CITY OF REDDING
REPORT TO THE PLANNING COMMISSION

ITEM NO.	4c(1)
MEETING DATE	4-29-10
APPROVED BY	
STAFF AUTHOR	
PLANNING MANAGER

SUBJECT: Salt Creek Heights Subdivision/Planned
Development (S-15-07, PD-11-07, RZ-6-07)
Field Trip

ITEM 4c(1)
ATTACHMENT "D"

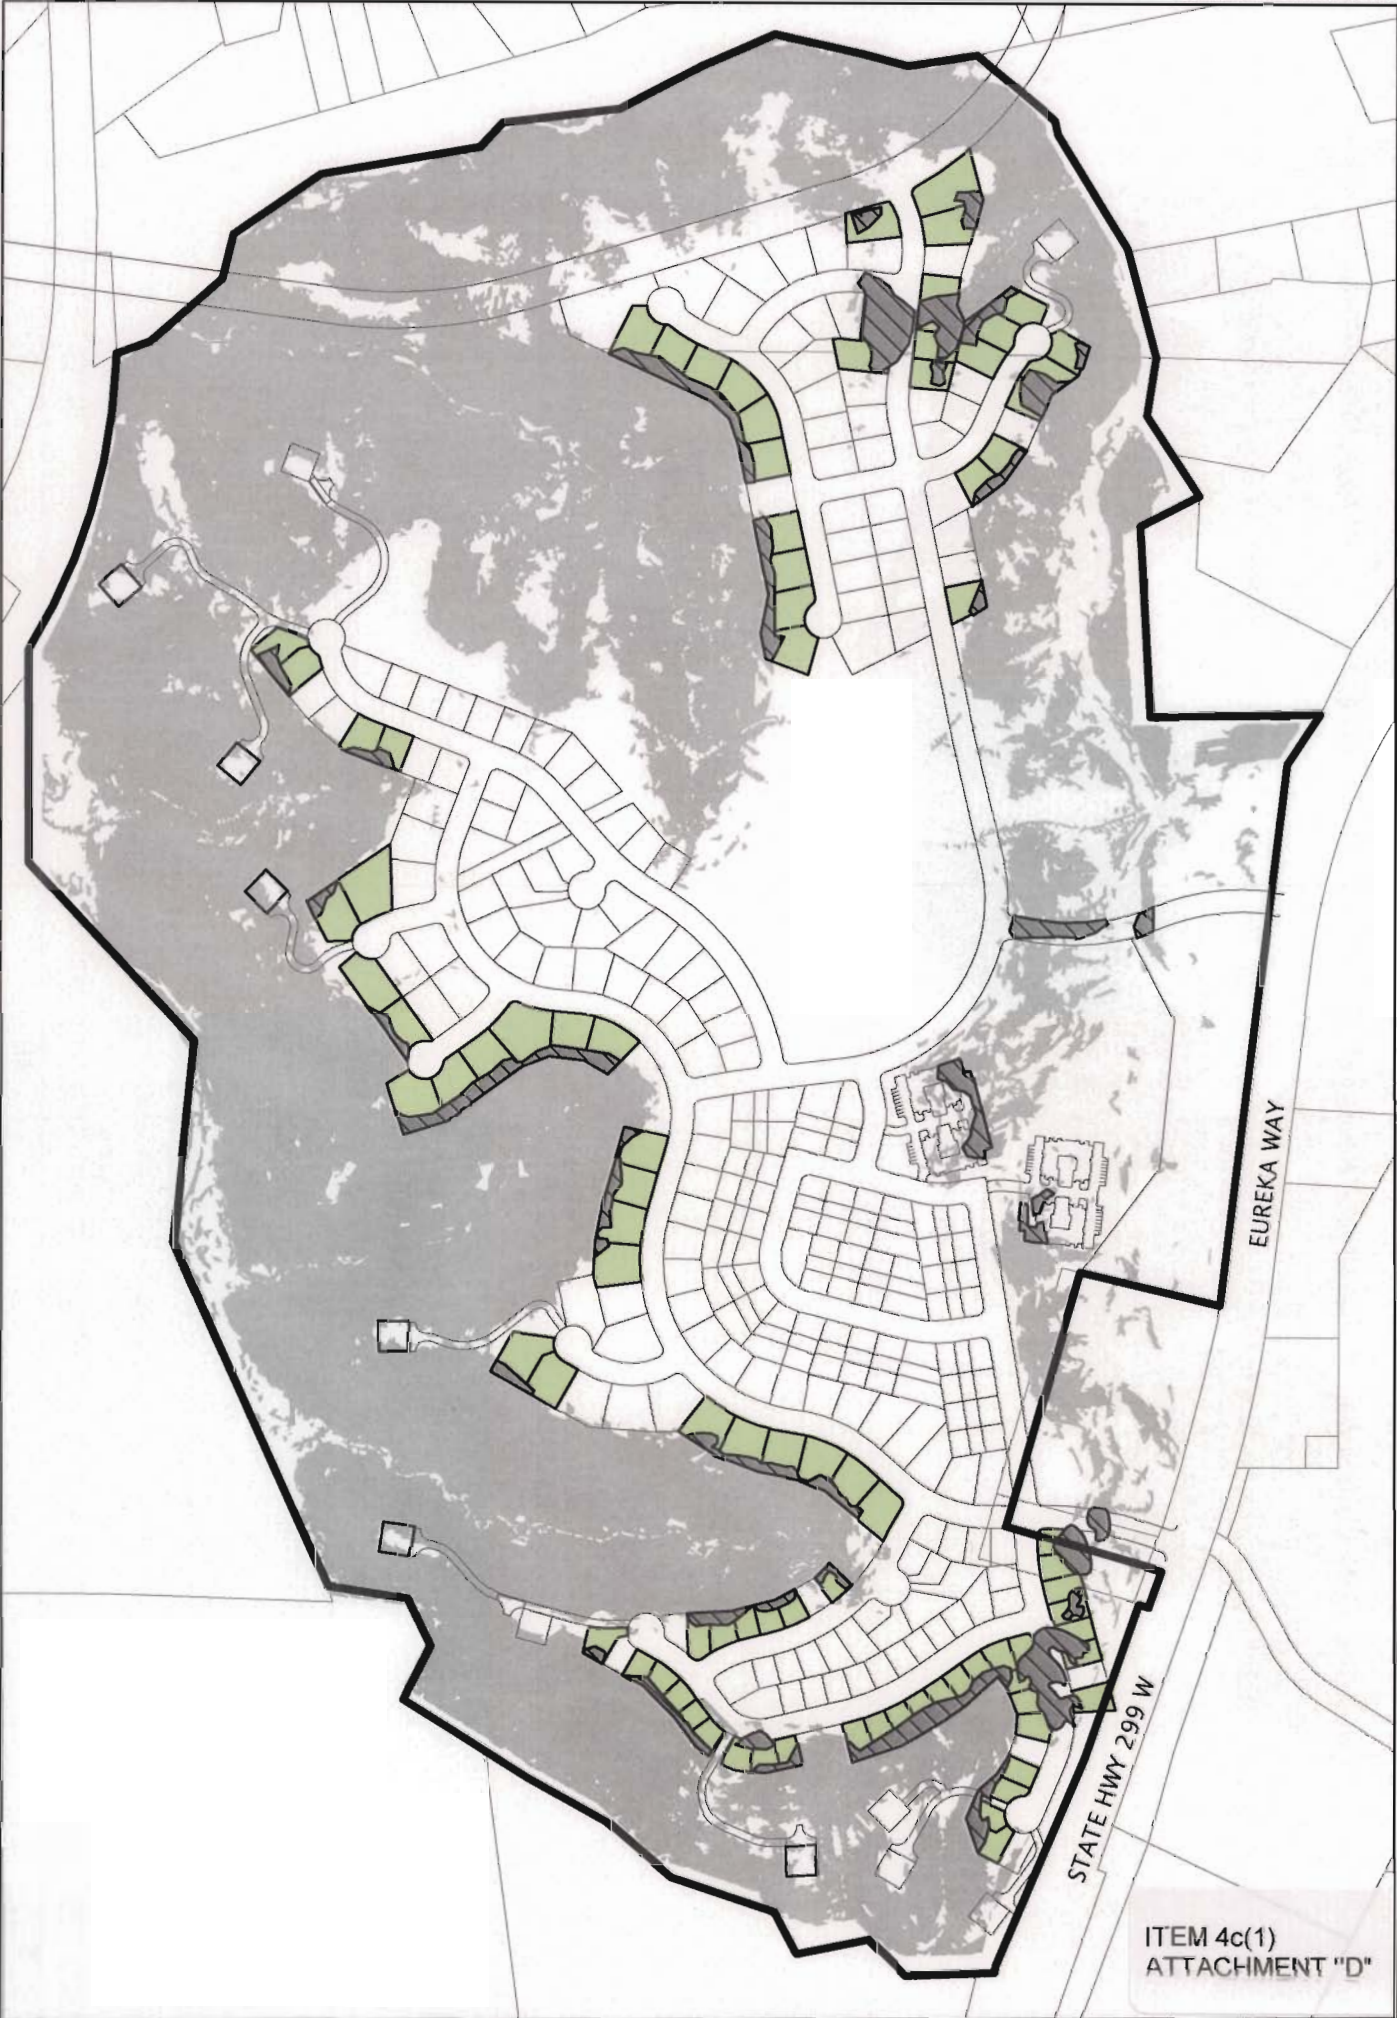
Attachment "D" illustrates how past practice of allowing slope encroachments may apply to the Salt Creek Heights proposal by depicting those areas within lot boundaries (not including the outpads) that have 20 percent slope or greater. The total area of steep-slope encroachment for the project is in excess of five acres, and facilitates the development of approximately 75 lots and some number of apartments.

ITEM 4c(1)
ATTACHMENT "E"

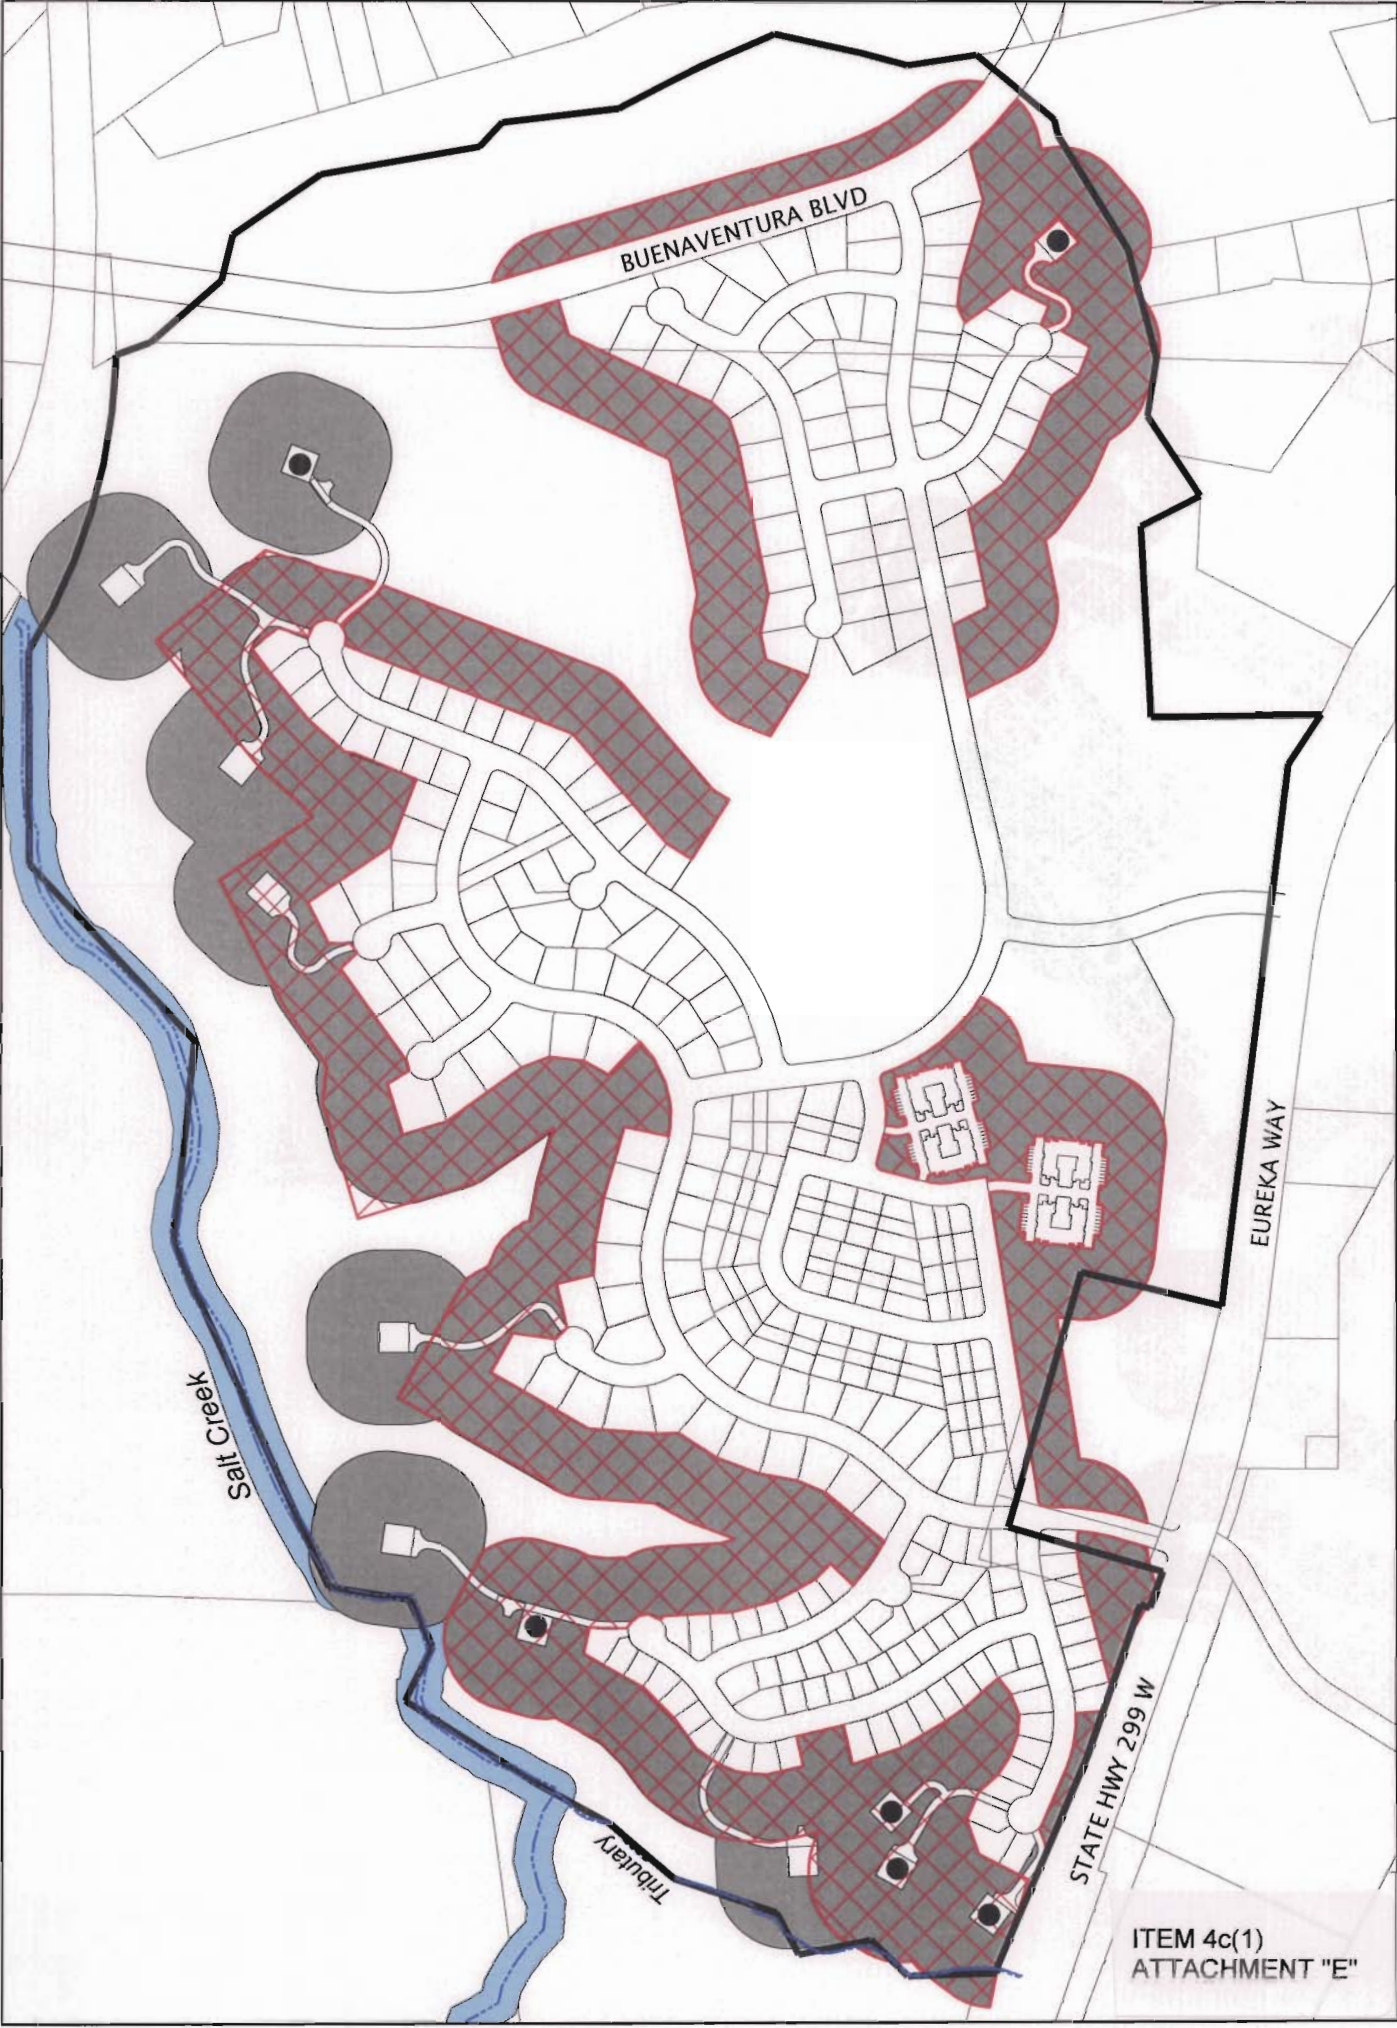
1. Encroach deep into the surrounding greenway area, diminishing the continuity benefits of uninterrupted open space.
2. Extend the required fire-fuel clearing well beyond that needed for the main body of development. Attachment "E" illustrates that these six outpads will necessitate an additional 17 acres of clearing on that portion of the site closest to Salt Creek. In fact, clearing for Lots 335, 339, and 341 extends the clearing to the creek or its main tributary. This exhibit is based upon the City's standard mitigation requiring clearing within 200 feet of the building pad; the applicant has submitted a project-specific fire-hazard study indicating that 130 feet of clearing is sufficient. The Fire Marshal has not yet concurred with the analysis. The project EIR identifies appropriate clearing techniques should clearing need to occur in close proximity to the creek.
